BID ADDENDUM 1

Project: Warwick Valley CSD
High School
Renovations, Field Work, Roofing and Exterior Bathroom Building

Engineer: Eisenbach & Ruhnke Engineering, P.C.
291 Genesee Street
Utica, NY 13501
E&R Project #: 05-21-04

SHEET NO.
**BB
P-100**

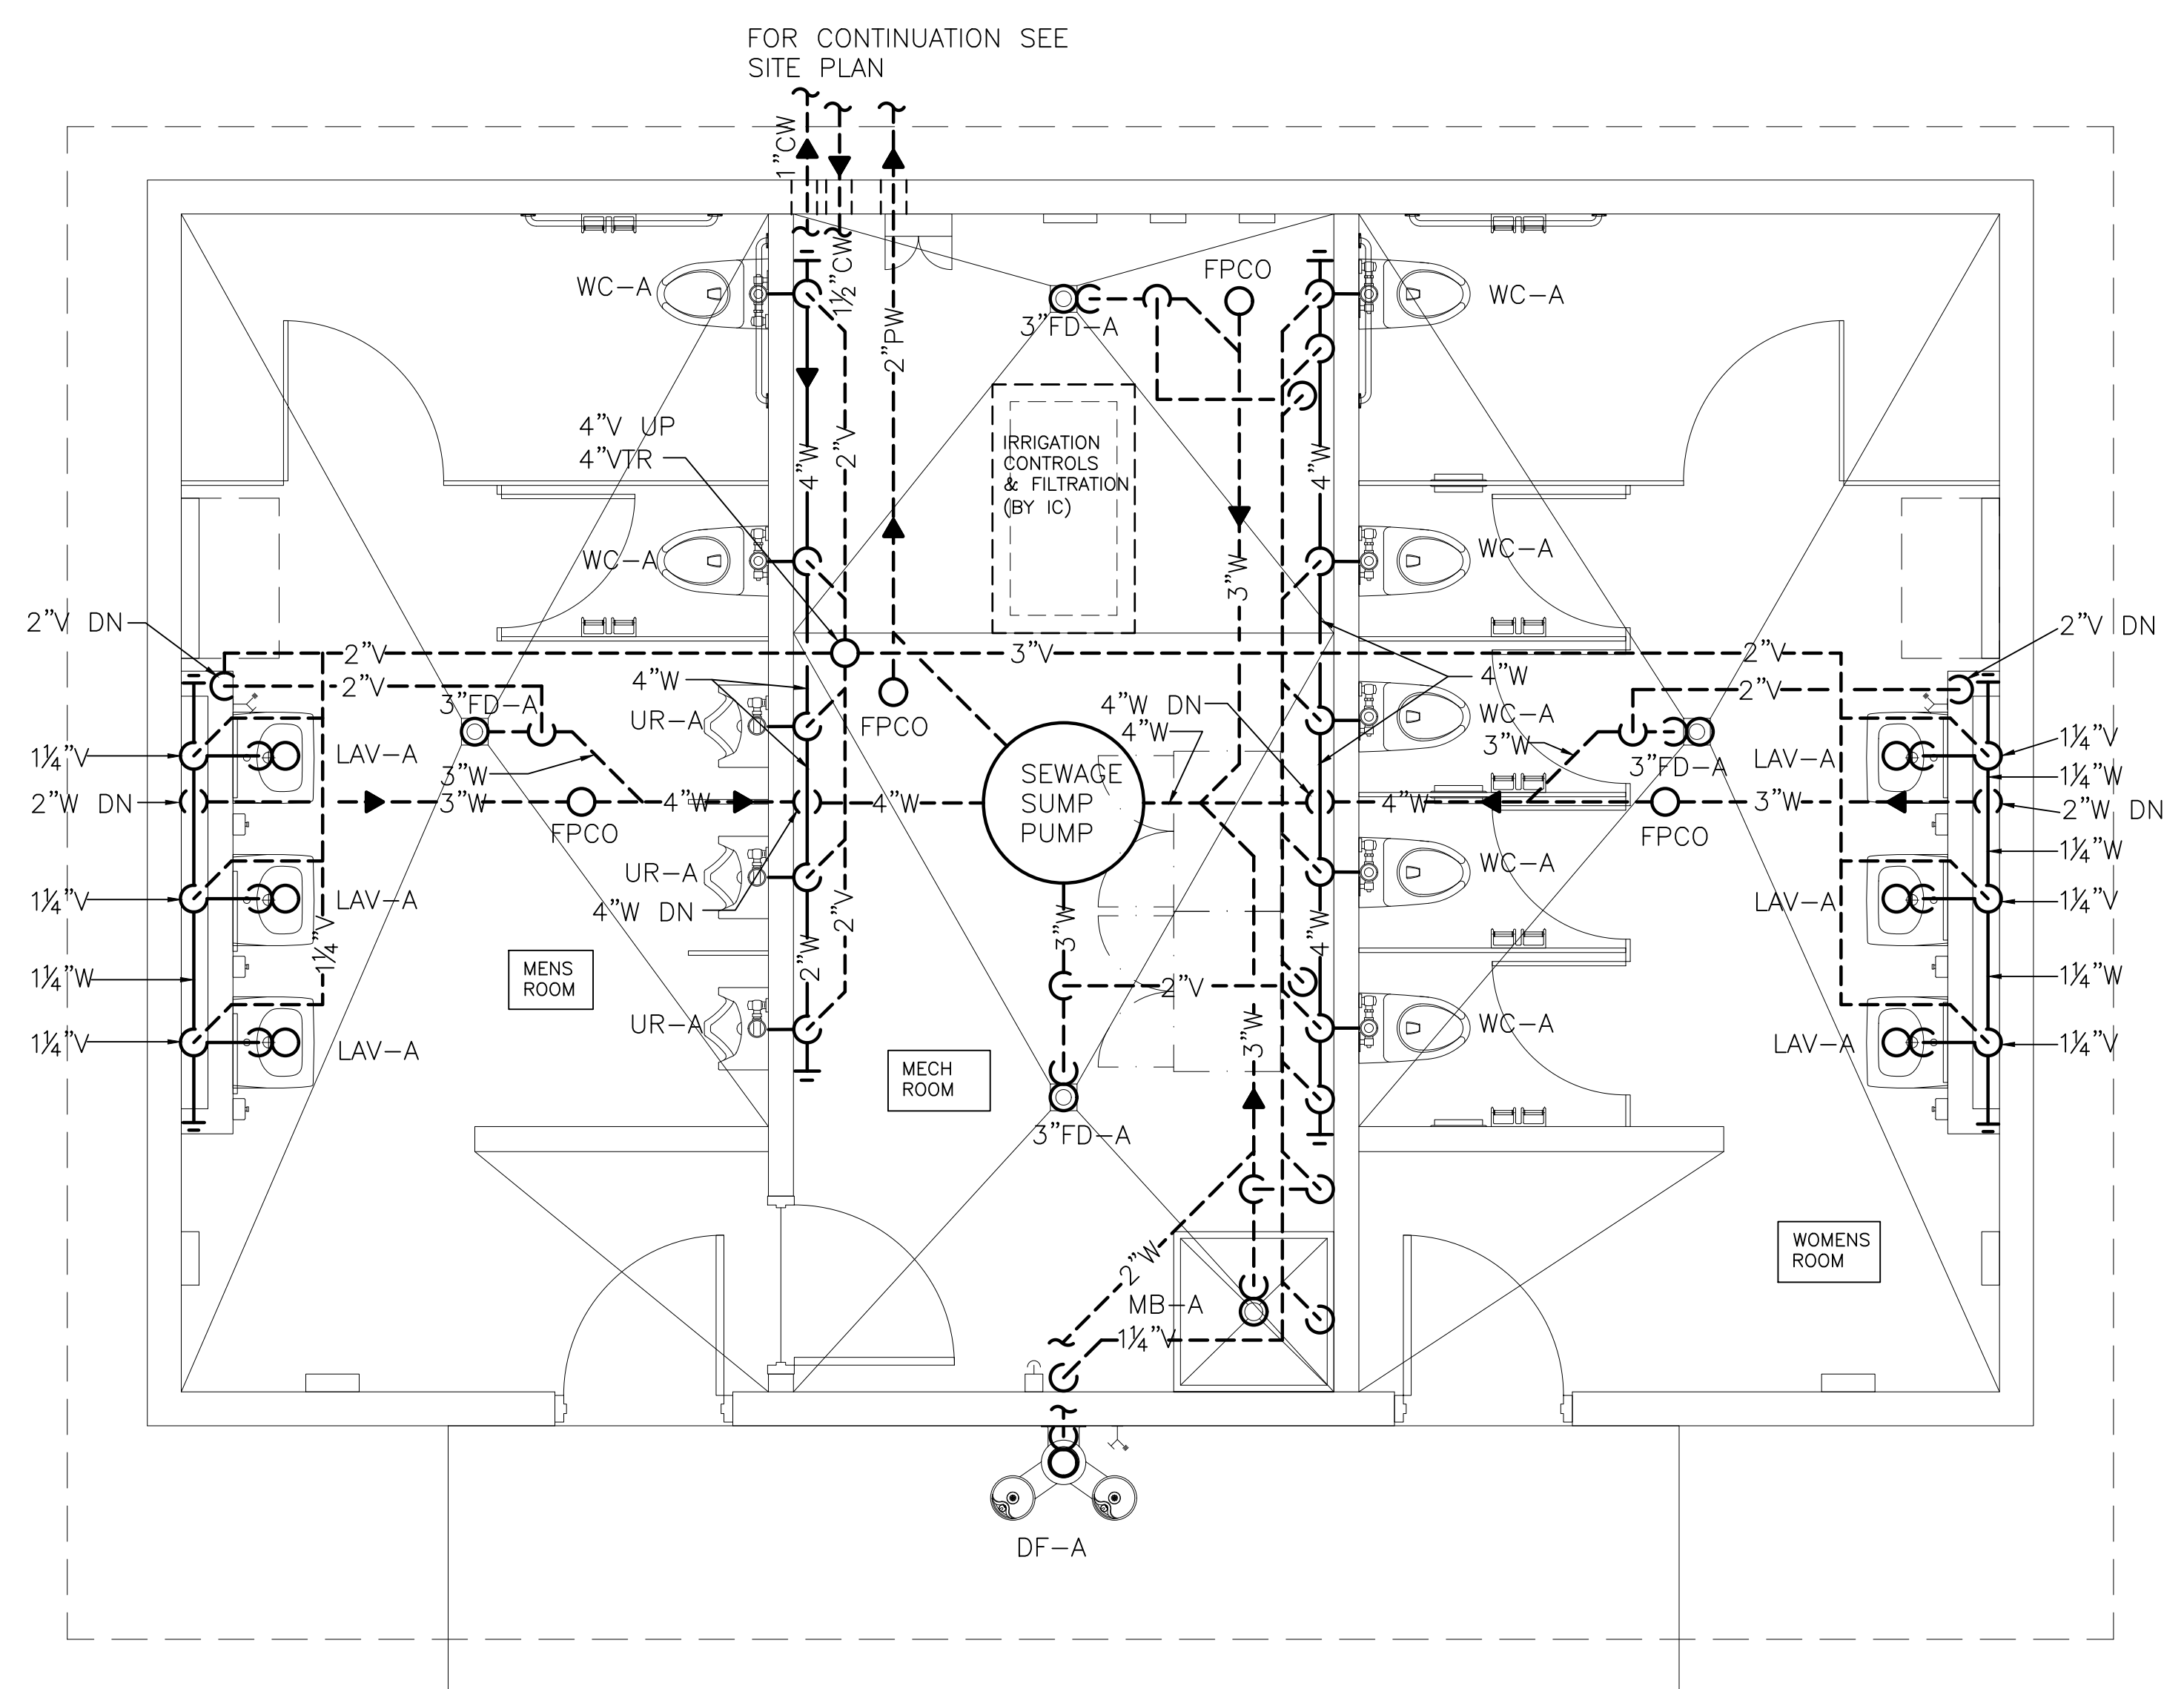
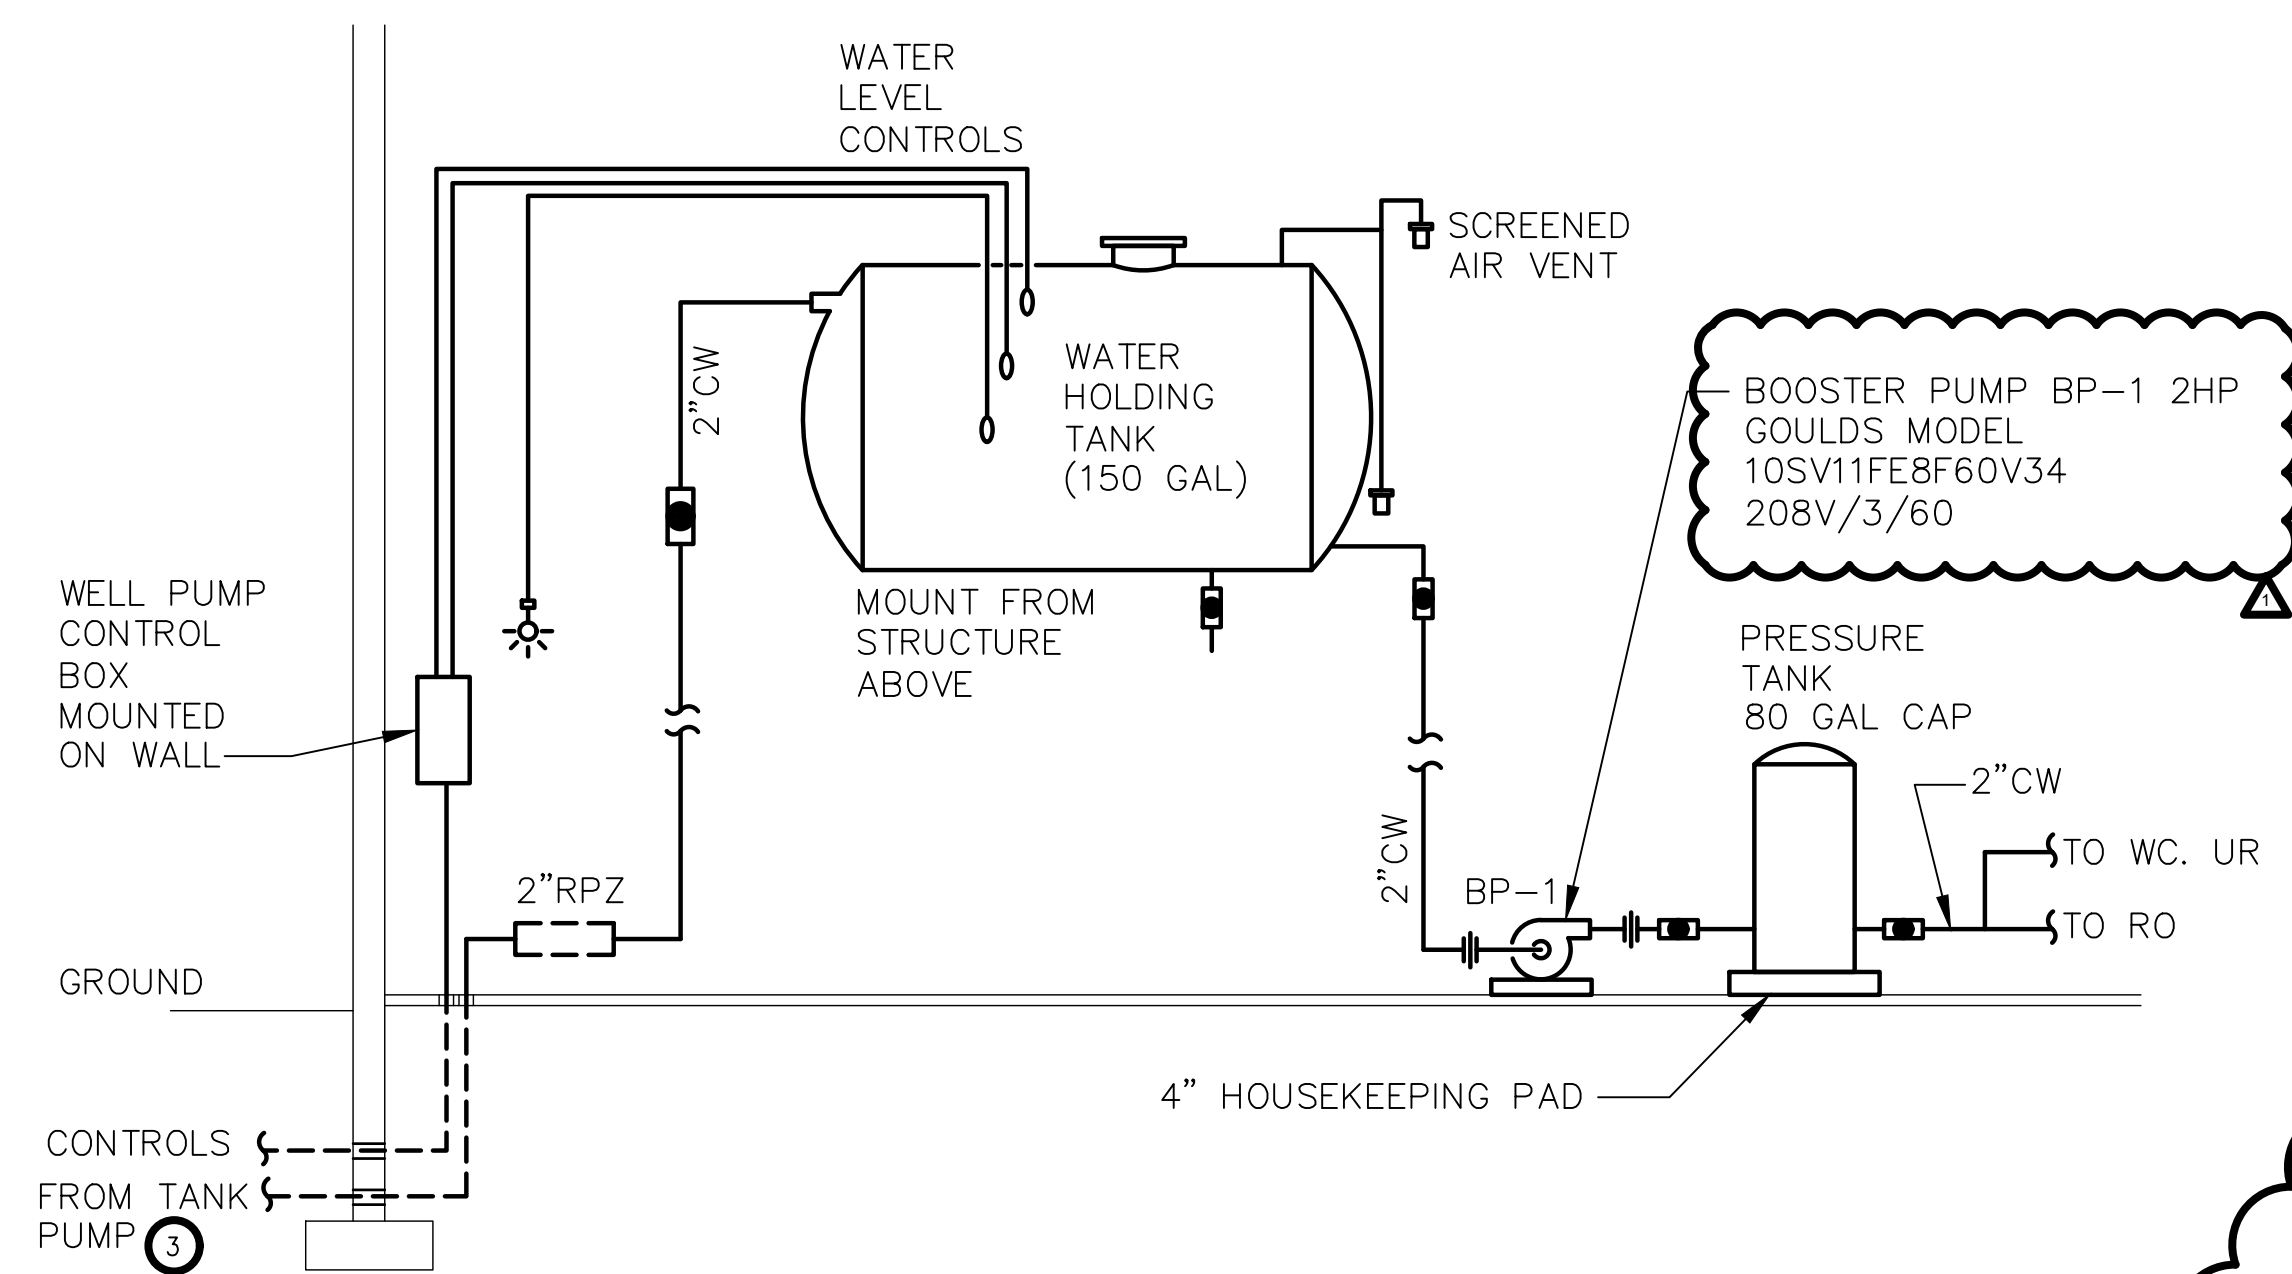
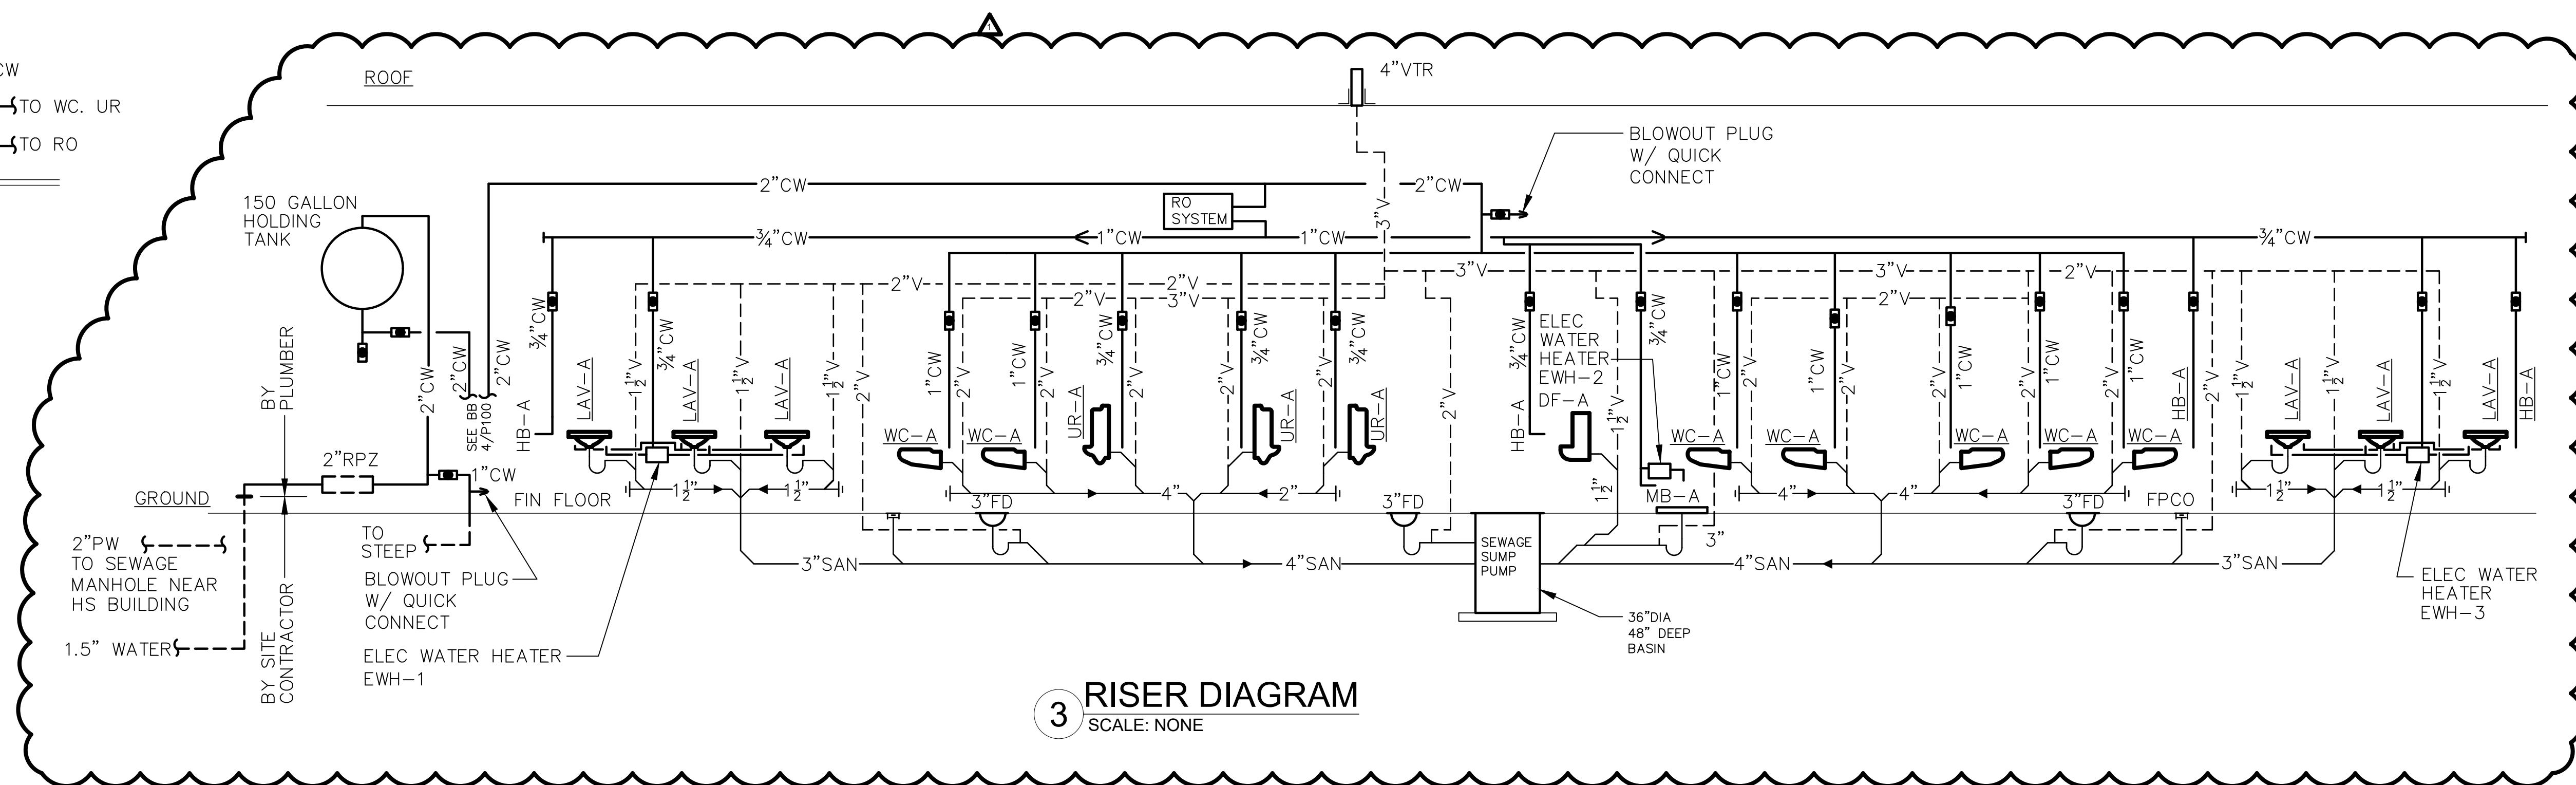
RFI-#1 – Will a revised drawing be issued to correct the issue as described above?

Attached Drawing shows revised pipe sizes.

1 PARTIAL ROOF PLAN - LOCATION OF NEW DROP CEILINGS NEAR CAFETERIAS/KITCHEN
SCALE:

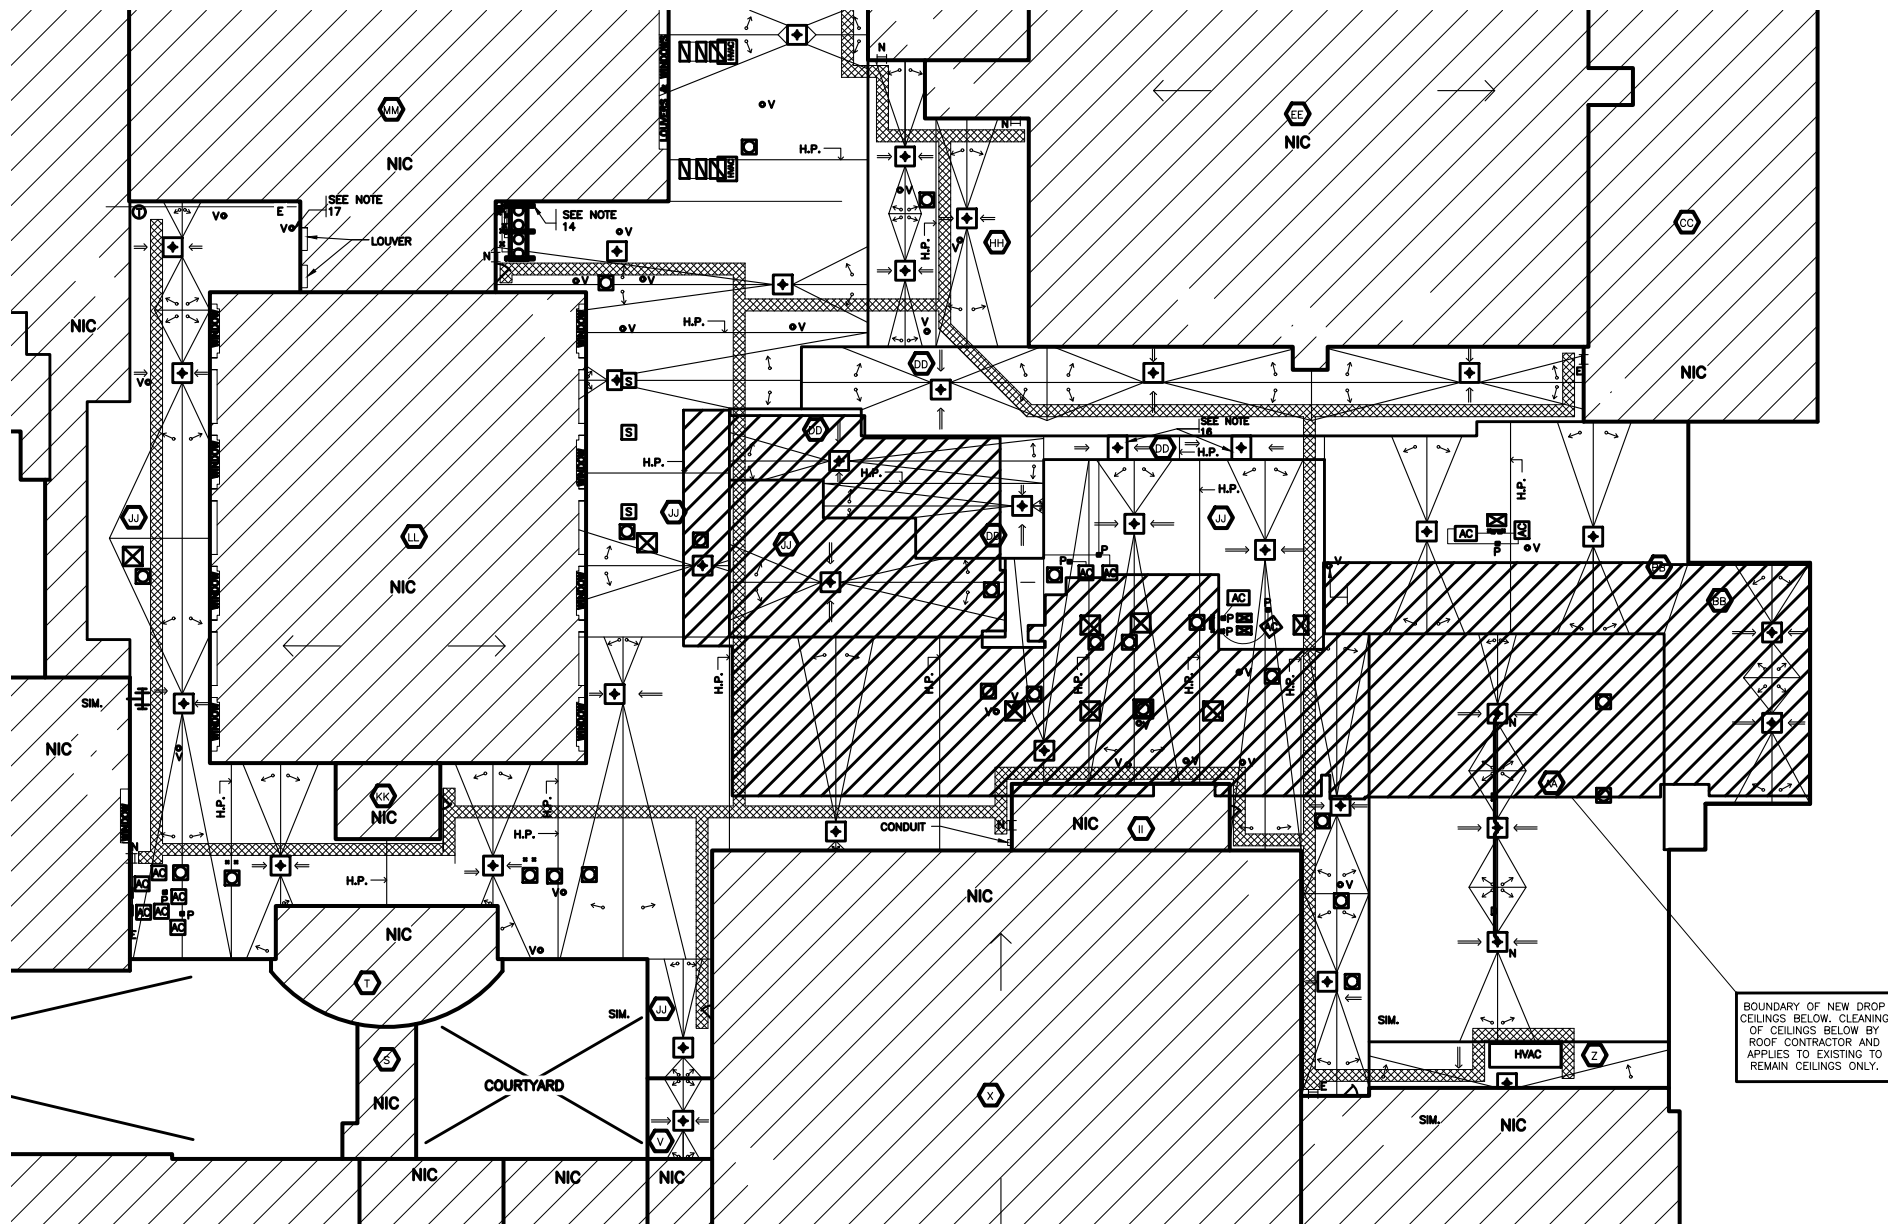
- Add the Attached Sketch SK-1 showing locations of new drop ceilings near Cafeterias/Kitchen.
